PLANNING, ZONING, & BUILDING DEPARTMENT
PZ&B Staff Memorandum: Architectural Commission

SUBJECT: ZON-24-0007 (ARC-24-0016) 403 BRAZILIAN AVE

MEETING: JUNE 26, ARCOM

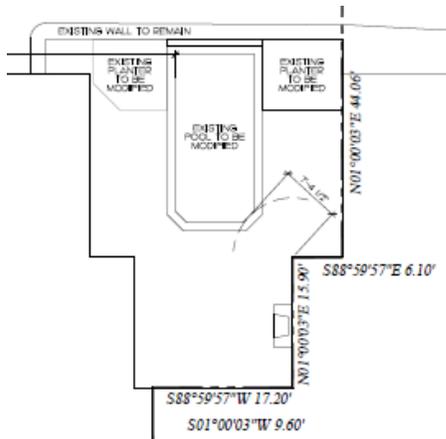
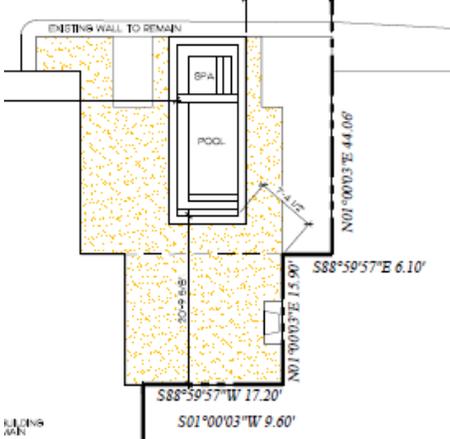
An existing pool is situated in the northeast rear of the property which the applicant seeks to remove and construct a new pool with a different design. Construction of the new pool requires two variances (1) for the location of the pool equipment which will remain in the existing location however is not within the 25' from edge of water as required and (2) to place the new pool at 7'4" in lieu of the 10' required from the east property line.

The parcel currently does not comply with the current code as it relates to placement of the pool, pool equipment and open space. The modifications in this application require variances to maintain the existing non-conformities. Per Section 66-285 the applicant does not seek to modify more than 50% of the existing landscape/greenspace which does not require open space come into compliance although the application does provide an increase of less than 1%.
